UNITED STATES PATENT AND TRADEMARK OFFICE

| APPLICATION NO. | FILING DATE | FIRST NAMED INVENTOR | ATTORNEY DOCKET NO. | CONFIRMATION NO. |
|---|-------------|----------------------|-------------------------|------------------|
| 10/611,419 | 06/30/2003 | Yee-Chung Fu | Q01-1041-US1 / 11198.71 | 5714 |

Final Rejection

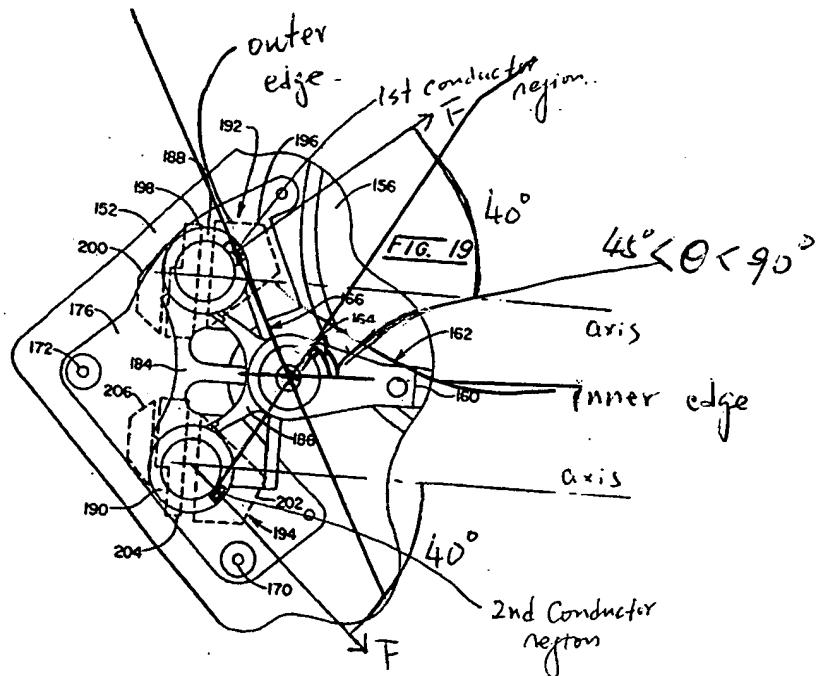
Claims 1, 32, 49, and 59; Wasson shows a disk drive including; an inherent storage disk having a plurality of tracks; a data transducer 18 (Fig. 2; column 6, line 18); an actuator assembly 162 (Fig. 19) that supports the data transducer over one of the tracks, the actuator assembly having a rotatable actuator hub 164 and a longitudinal axis (Fig. 20), the actuator hub being subjected to a resultant force that can cause track misregistration of the data transducer during movement of the actuator assembly; and a positioner that moves the actuator assembly relative to the storage disk, the positioner including (i) a magnet assembly 194+196 and etc. (Column 12, lines 44-64) that generates a magnetic field, and (ii) a first conductor region 188 (See Fig. 19 attached below with added marks) that cooperates with the magnet

assembly to generate a first force that is directed at an angle having an absolute value that is greater than zero degrees and less than approximately 45 degrees relative to the longitudinal axis of the actuator assembly inherently at least partially offset the resultant force at the actuator hub.

With regard to claims 49 and 59, Wasson further shows that the magnet assembly having an inner edge and an opposed outer edge relative to the actuator hub, and the first conductor region that is positioned between and defined by the edges of the first magnet (See the figure above).

Claims 2, 50, and 60; Wasson further shows a second conductor region 190 that cooperates with the magnet assembly to generate a second force (Fig. 19 above) that is directed at an angle having an absolute value that is greater than zero degrees

Claims 41, 55 and 64, Wasson further shows that the first conductor region and the second conductor region are positioned at an angle θ having an absolute value that is greater than approximately 45/60 degrees and less than 90/89 degrees relative to the longitudinal axis of the actuator assembly (See Figure shown above).

- Examiner’s position: Applicant uses term “conductor region” in claims; therefore, a sector of the coil is properly read as a “conductor region.”
- Applicant argues: “the small vectors would not offset the resultant force, but would appear to be additive to it.”
 - Examiner’s position: The resultant force is a vector. Offsetting a vector can be either changing the magnitude or turning the orientation of the vector. As far as the force is not in the same direction as the resultant force, the addition of the force will, at least, turn the orientation of the resultant force, i.e. offsets the resultant force.
